APPEAL SUMMARY

Appeal ID: 20580	Project Address: 4415 SW Fairview Blvd
Hearing Date: 7/3/19	Appellant Name: Mark Engberg
Case No.: B-004	Appellant Phone: 503 416 0139
Appeal Type: Building	Plans Examiner/Inspector: Mike Walkiewicz, Amit Kumar, Jason Butler-Brown
Project Type: residential	Stories: 2 Occupancy: R-1 Construction Type: V
Building/Business Name: None	Fire Sprinklers: No
Appeal Involves: Alteration of an existing structure	LUR or Permit Application No.: 19-183014-RS
Plan Submitted Option: pdf [File 1] [File 2] [File 3] [File 4] [File 5] [File 6]	Proposed use: Single Family

MARTIN RHODES HOUSE
DRIVEWAY REPAIR
4415 SW Fairview Blvd
Portland, OR, 97221

BCA1.1

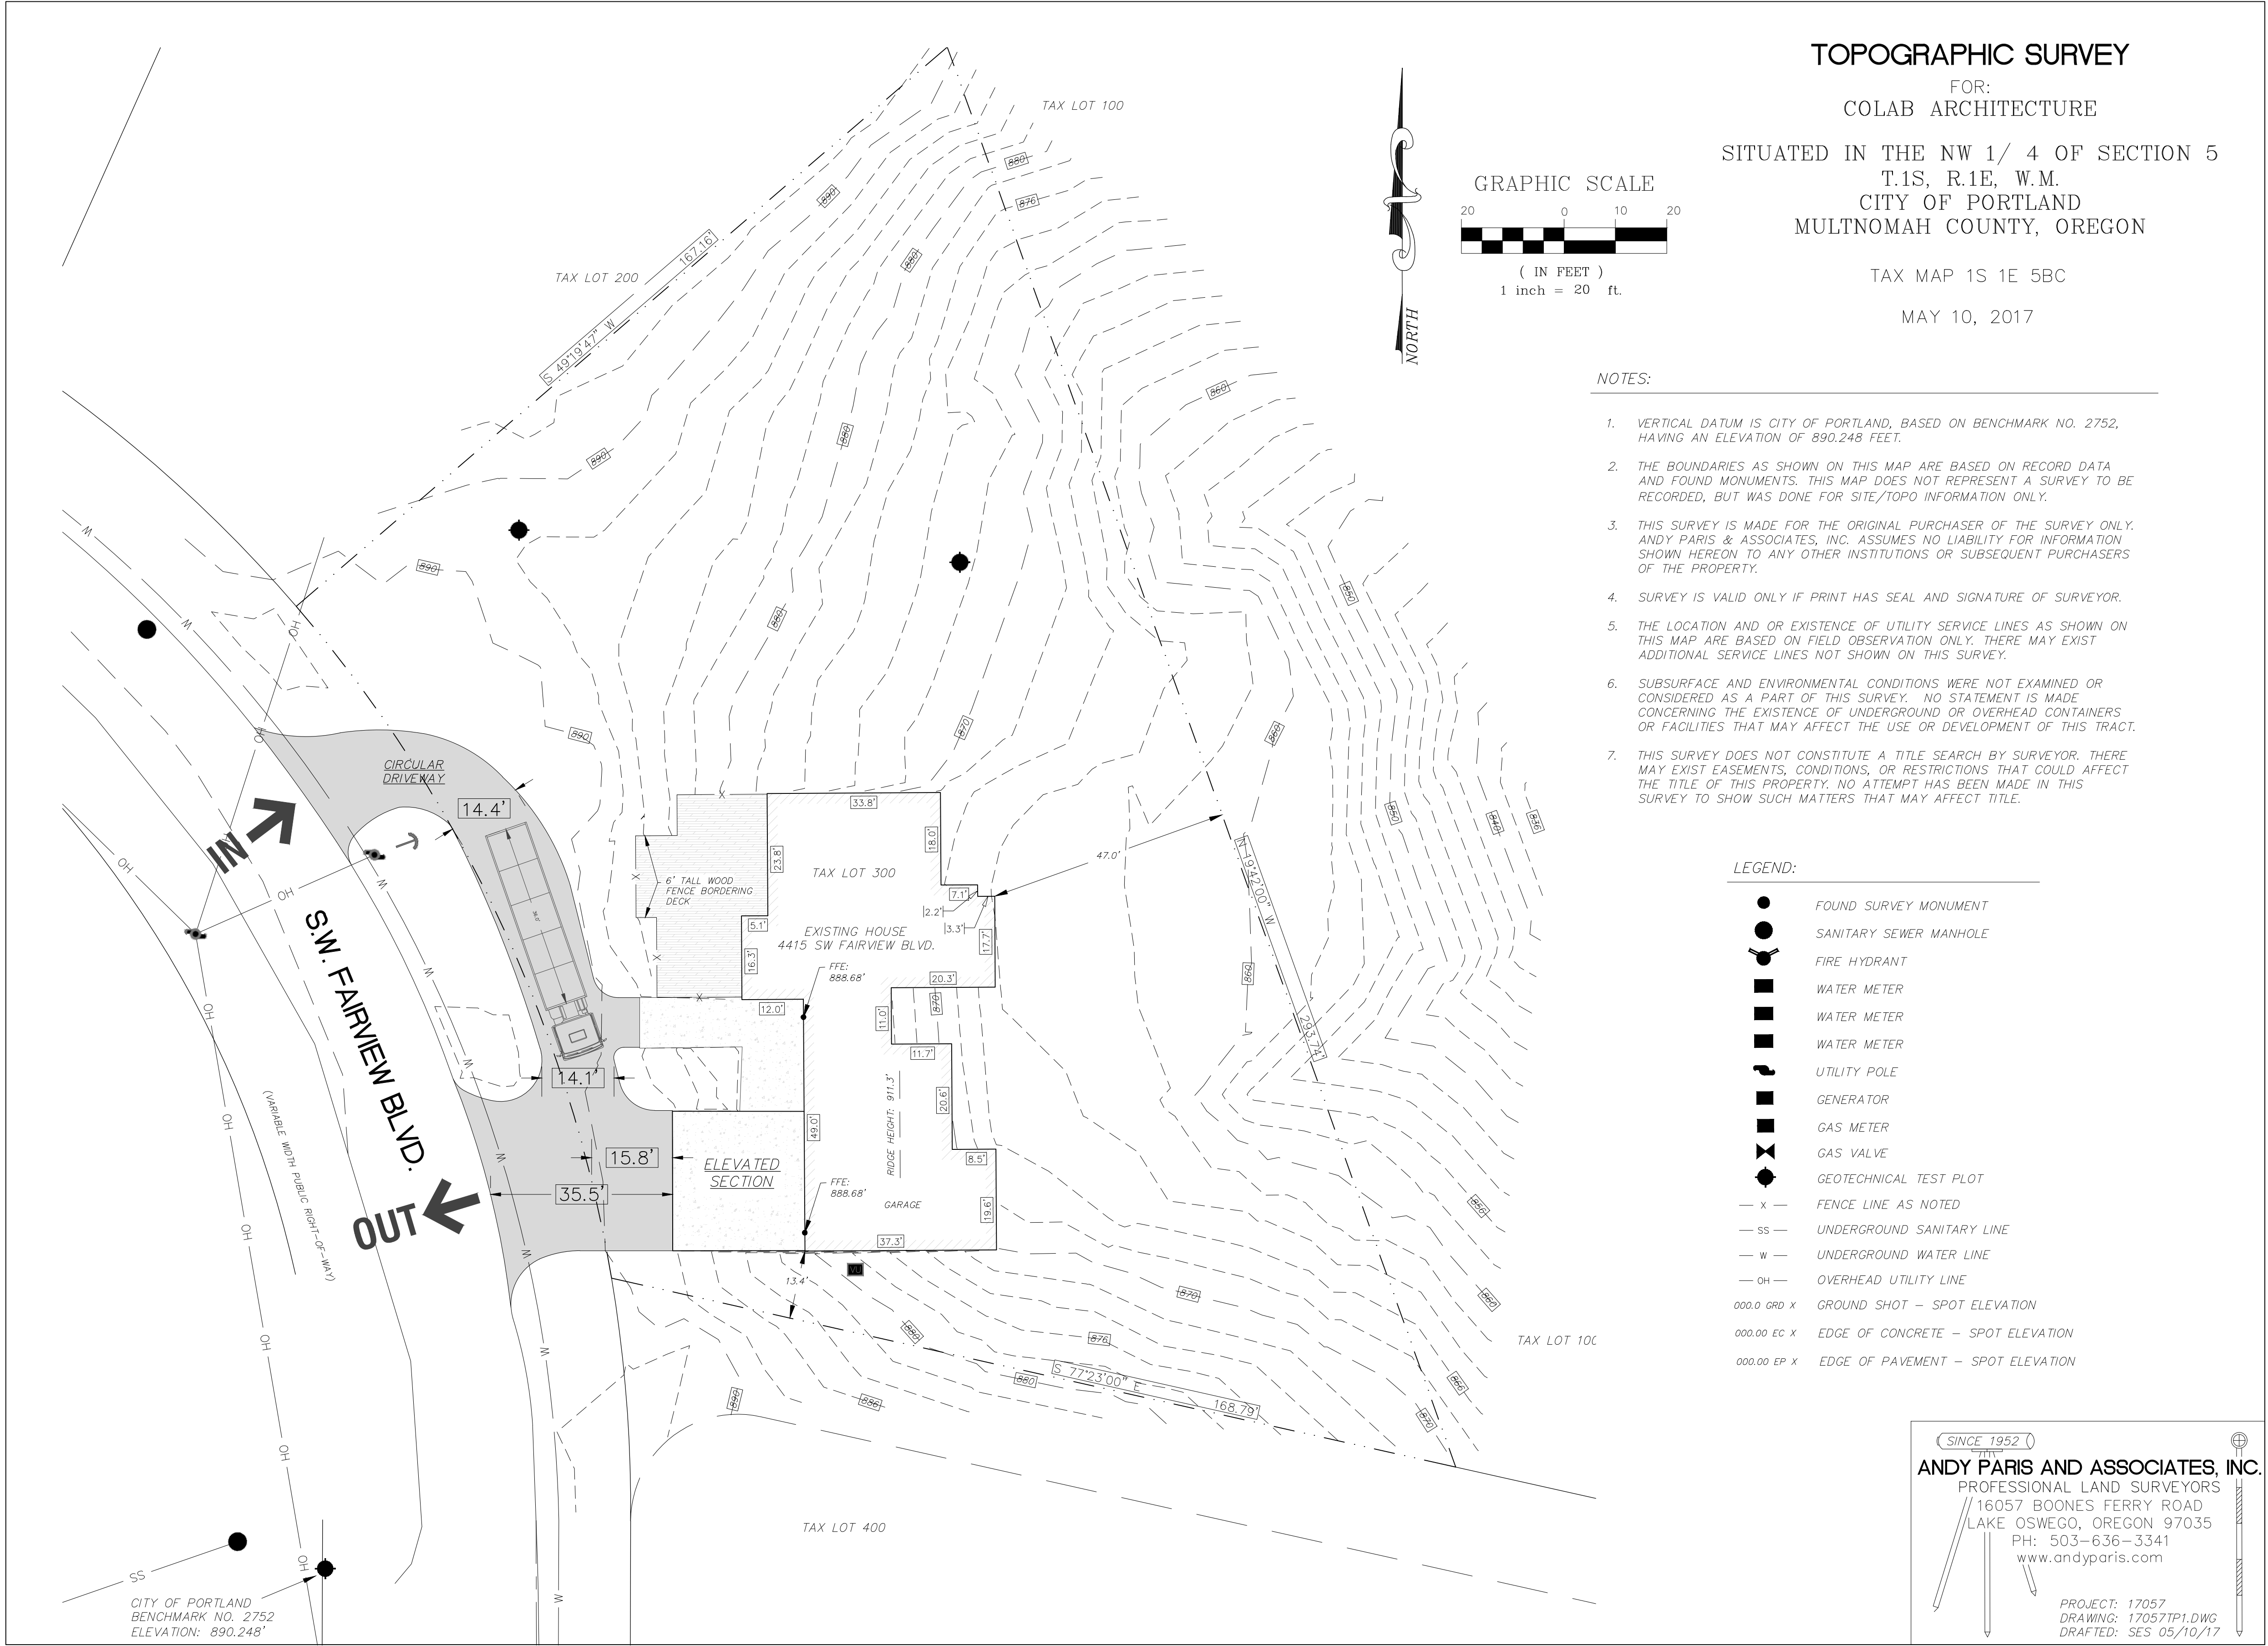
Code Section	OSSC/16/#2
Requires	The PDOT has supplemental requirements to OSSC/16/#2 for ramps or decks that are adjacent to a public roadway. Under these requirements the ramps or decks need to be designed for live load requirements of AASHTO HS-20. Design should accommodate for Trucks such as Garbage trucks and Moving trucks. See enclosed BDS Code Guide.
Proposed Design	<p>The Project scope is to replace an aging elevated driveway that was built in 1976. The existing structure is comprised of a concrete slab on plywood on 2x8 joists supported by a wood glulam beam which is supported by 4x4 wood columns supported on concrete piers and a concrete retaining wall. The existing elevated driveway is nearing the end of its useful life. The slab and wood section will be removed and replaced. The new replacement design is the same size and shape in plan. It is comprised of a 4 inch Concrete slab on PT Plywood on PT sleeper for slope on PT plywood supported on 4x8 PT joists supported by a steel beam W12x19 which is supported on 4 Inch round steel columns supported by the existing concrete foundation. The new driveway is designed to support 40 psf and a point load of 3,000 lbs. The driveway will also be flashed properly to help maintain its integrity.</p> <p>The existing conditions on the site provide a circular on-grade driveway with two points of entry or exit. The on-grade driveway is long enough and wide enough to accommodate the largest truck, listed in the code, to park and turn around without crossing the elevated driveway section. The elevated driveway is 35.5 feet east of the Fairview Blvd roadway and 15.8 feet from the property line. See enclosed document BCA1.0 and BCS 1.1.</p>

The reason for the alternate is that IF the new elevated driveway is designed for truck loads, we will need to remove and replace the existing concrete footings and retaining wall for both the driveway and existing house. That will potentially put the house and foundation in jeopardy during removal of the existing foundation. This would also require the removal of 2 mature trees adjacent to the driveway. The new design will make the elevated driveway safer in terms of longevity plus we are adding a safety curb to each side of the drive. The access to the house will remain the same. Energy conservation will not change. Large truck and fire apparatus access is currently already in place on the existing circular on-grade driveway.

Replacement of existing elevated driveway with reduction in minimum required structural design load: Granted provided signage is posted "No Heavy Trucks".
Appellant may contact John Butler (503 823-7339) with questions.
